TEXAS COMMISSION ON ENVIRONMENTAL QUALITY

Re: Edwards Aquifer, Comal County

Name of Project: **Setterfeld Estates**; Located along the east right-of-way of FM 3351 north of Cibolo Creek; Fair Oaks Ranch, Texas

Type of Plan: Request for Approval of a **Water Pollution Abatement Plan (WPAP)**; 30 Texas Administrative Code (TAC) Chapter 213 Edwards Aquifer

SETTERFELD ESTATES UNIT 1
 CITY OF FAIR OAKS RANCH, COMAL COUNTY, TEXAS

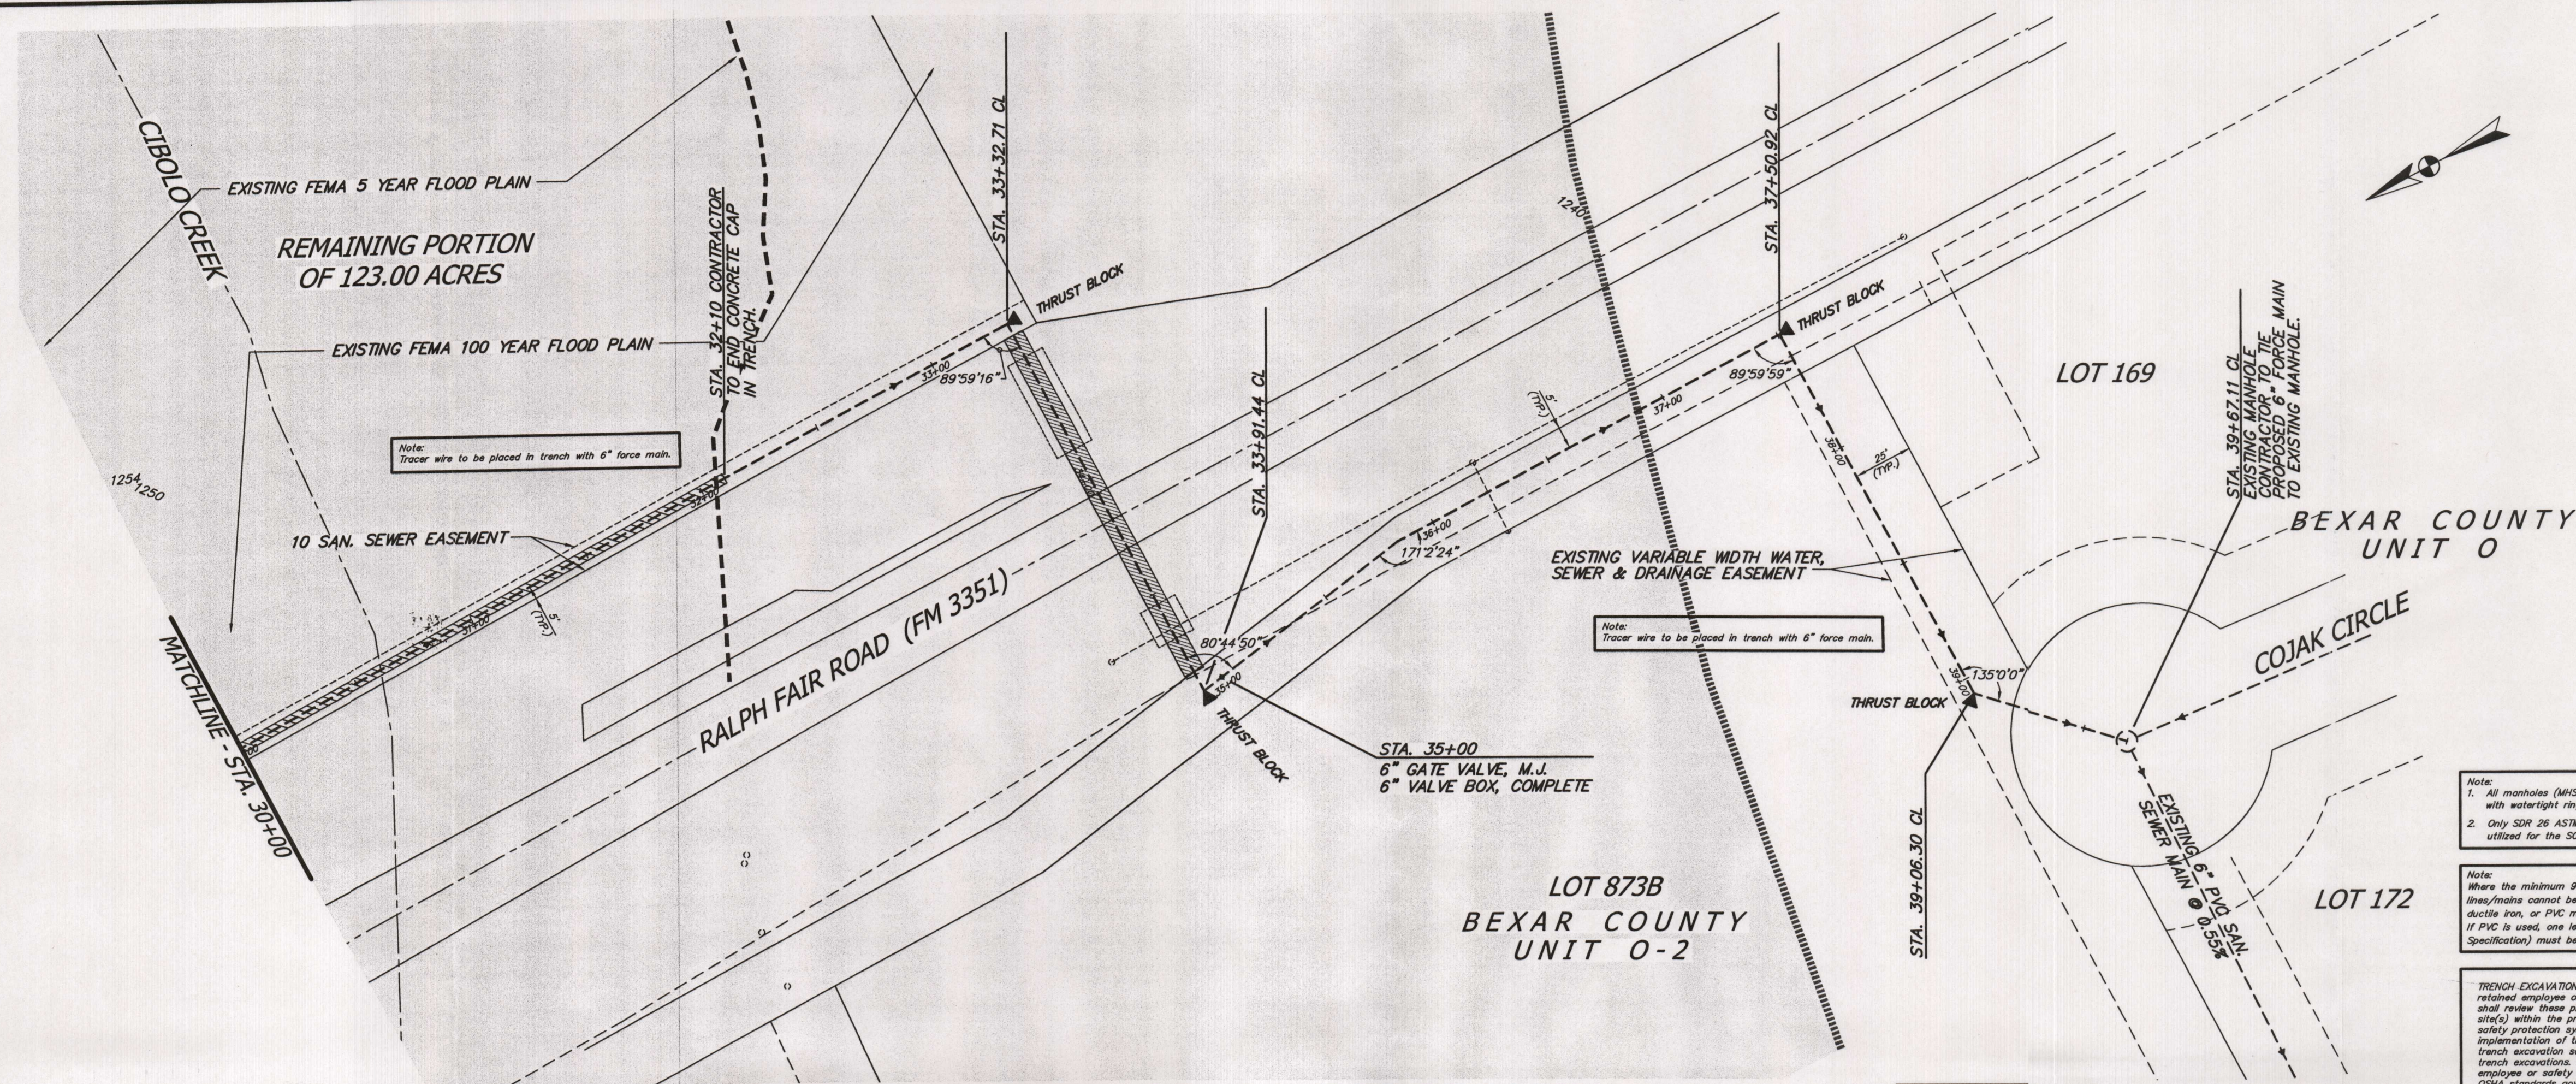
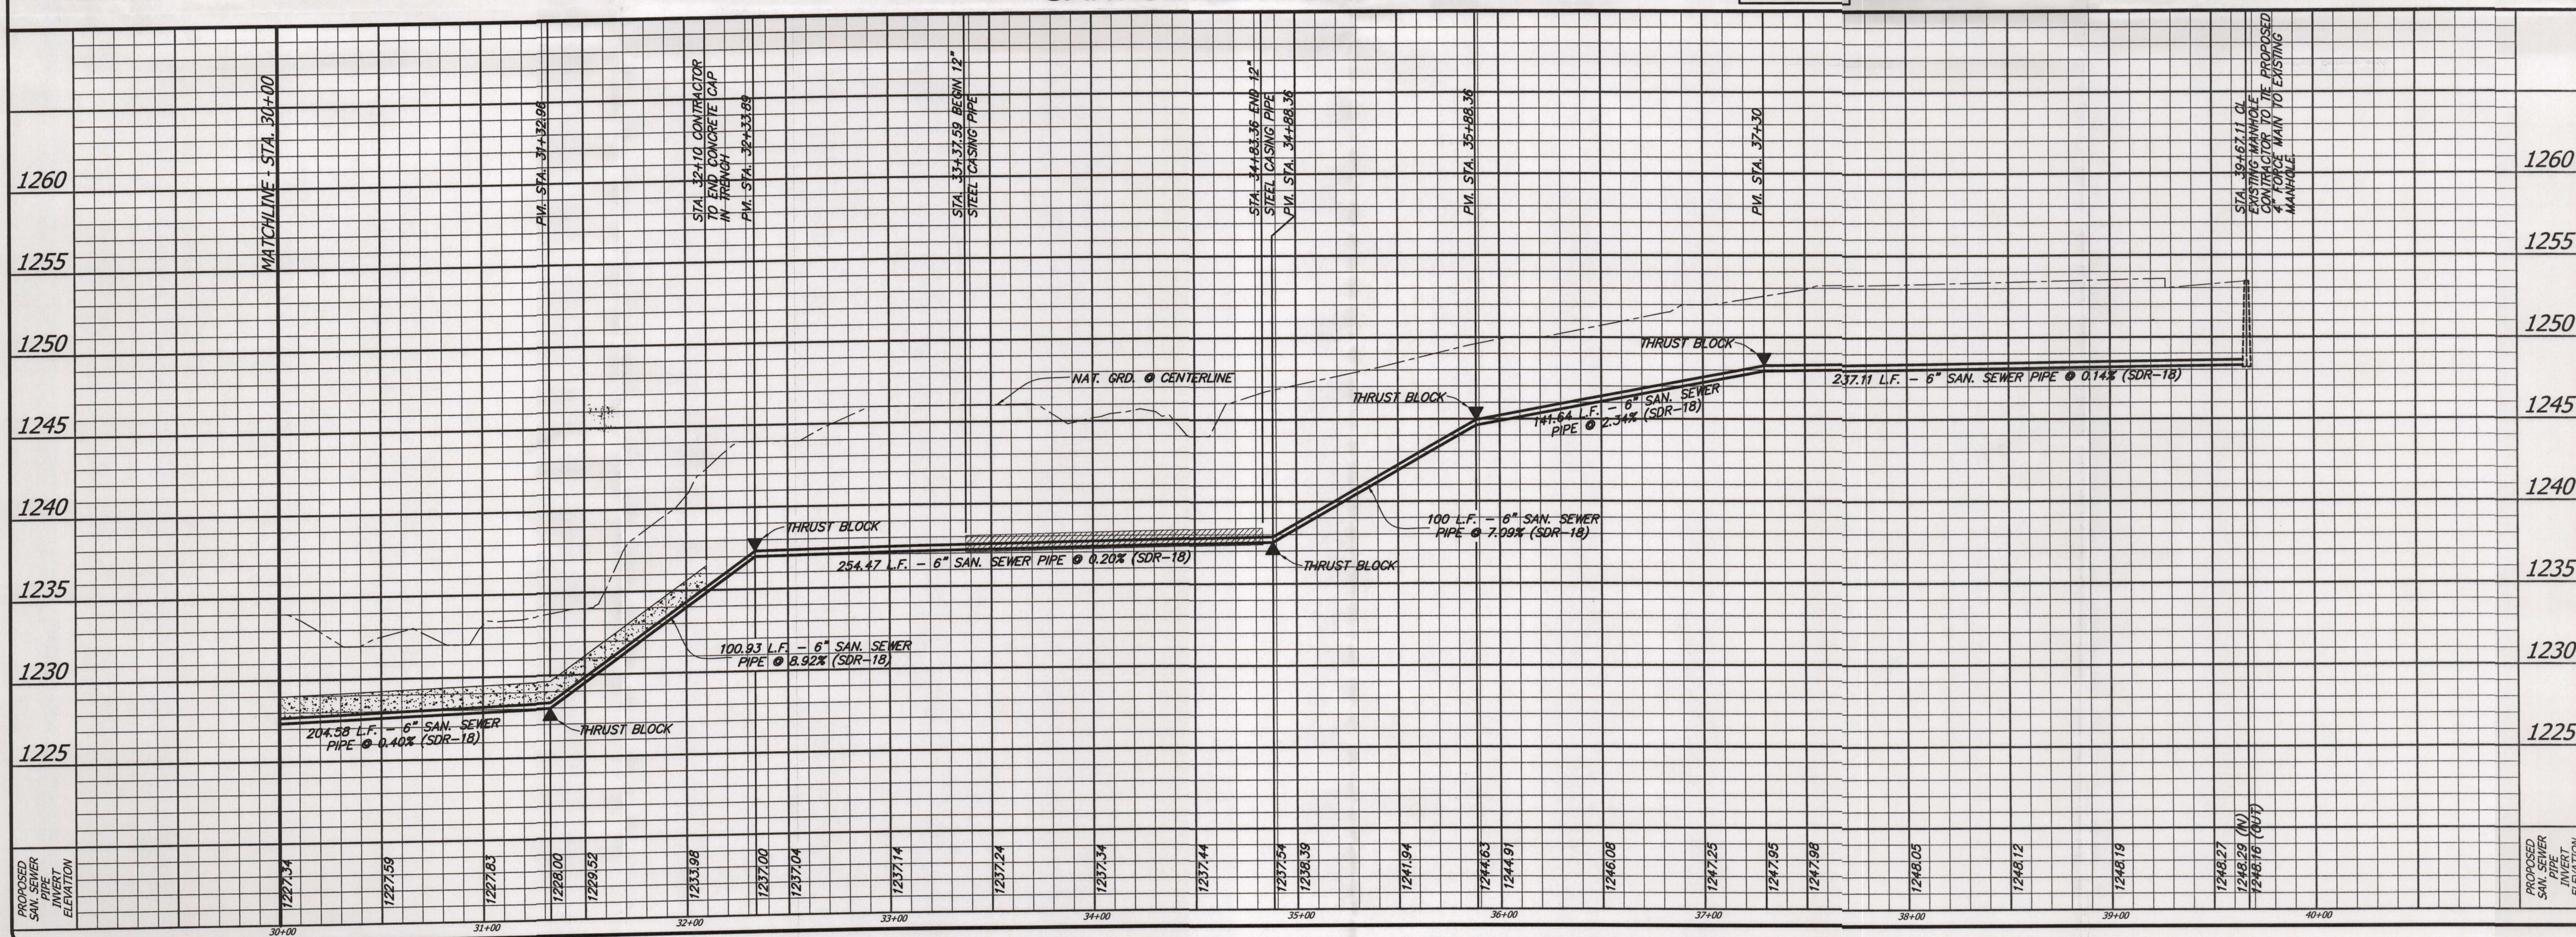
As per your fax of December 8, 2011 and our meeting on December 9, 2011, I have revised the force main calculations and the lift station pump design.

To assure 3fps of flow in the force main, the lift station pumps were revised to 275 gpm pumps. A "Duty Analysis" curve was produced for the force main vs. pump performance. This confirmed the pump selection.

Next the force main was analyzed for head loss at the design flow, including friction loss for fittings. The "Unibell Pipe Manual" was utilized to check the pipe design for Pressure Rating, Short Term design, and Cyclic Stress. Previous calculations used the pipe rating pressure of 150 psi as the operating pressure. The calculations have been revised using the operating pressure of 16 psi and the maximum pressure of 23 psi.

The AWWA Manual M23, Second Edition and the pipe rated pressure of 150 psi was utilized for thrust block calculation. The construction plans were updated to indicate the selected pump design, the addition of one air release valve at Station 12 + 80 and the thrust block sizing noted above.

- ▲ THRUST BLOCK
- 45° BENDS - 1.5' x 3' = 4.5 S.F.
- 90° BENDS - 2.1' x 4' = 8.4 S.F.

SW3P AND WATER POLLUTION ABATEMENT
SITE PLAN

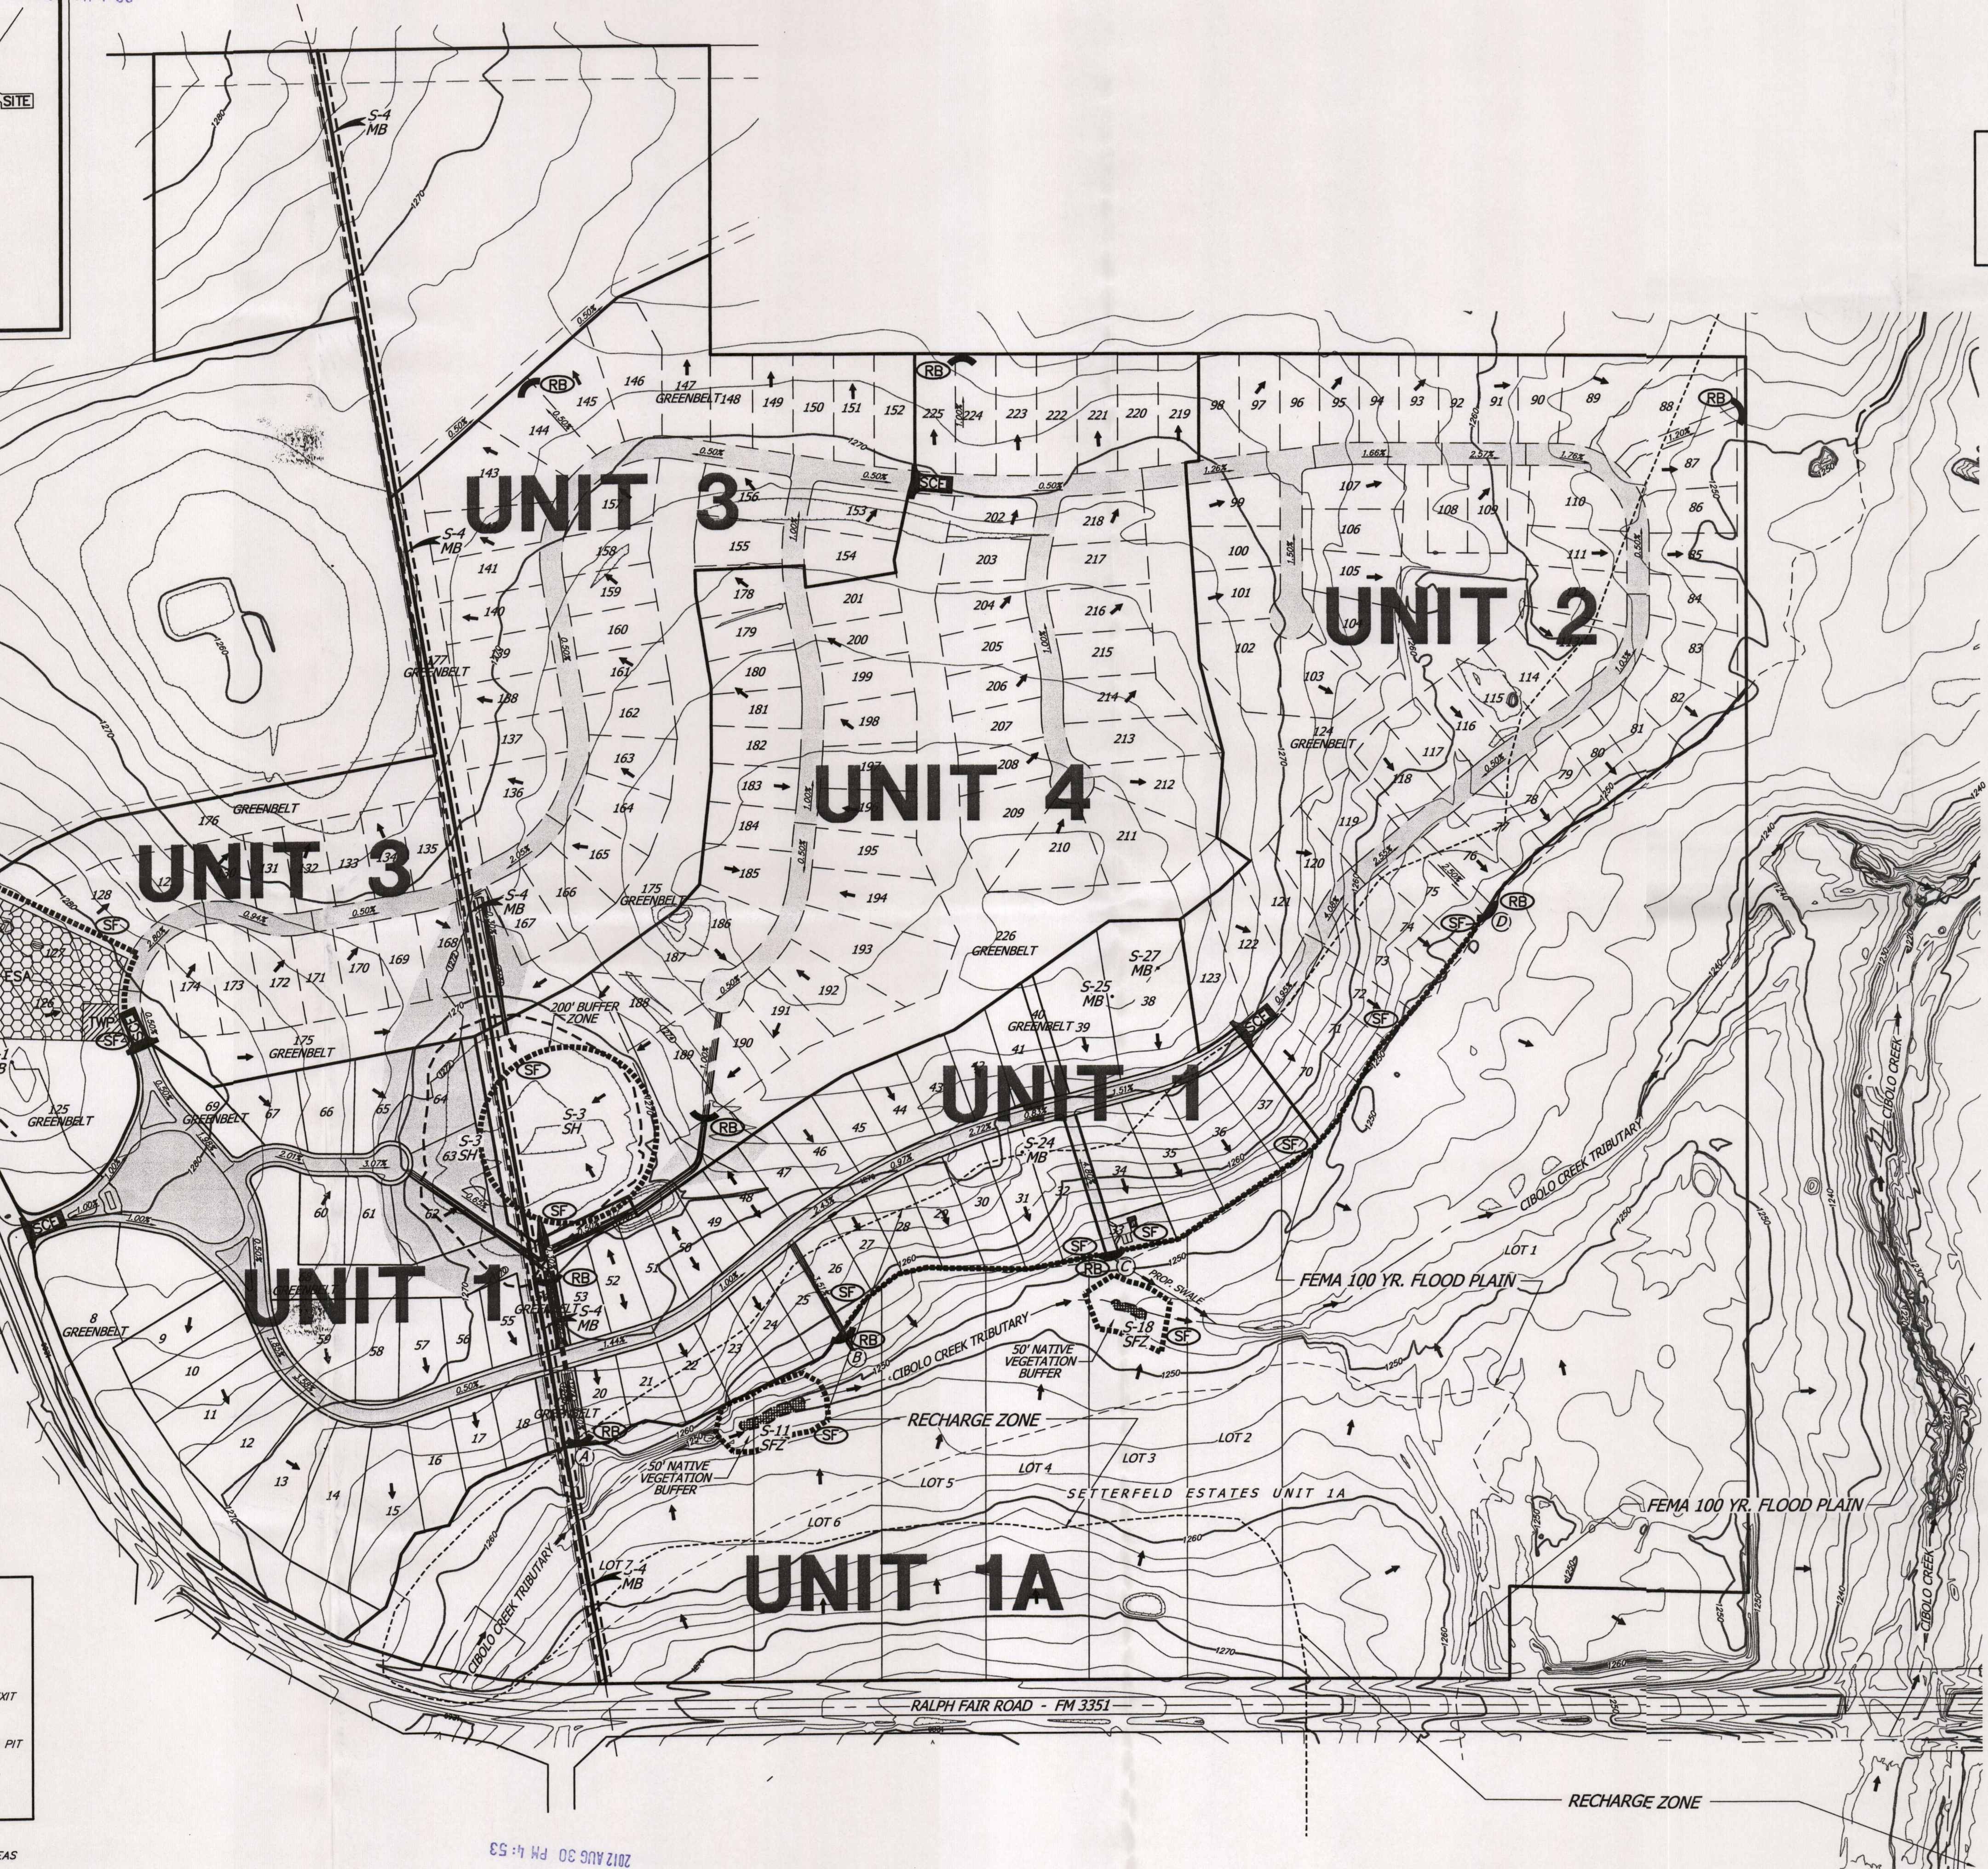
- 12) The site plan was modified to show the buffer for the sensitive feature to be in compliance with TCEQ TGM, section 5.1.2
- 13) The SWPPP notes on exhibit WPAP-2 has been modified to remove reference to a detention pond.

- 14) The location of the parks and open spaces have been labeled. The residential lots have been numbered. Disturbed areas are shaded on the site plan.

- 10) TCEQ-0600, Item 13, has been modified to address discharge waters and their treatment.
- 11) The residential lot layout has been revised to not contain the buffer zone for feature S-3. The buffer zone for feature S-11 is contained within the flood plain easement.
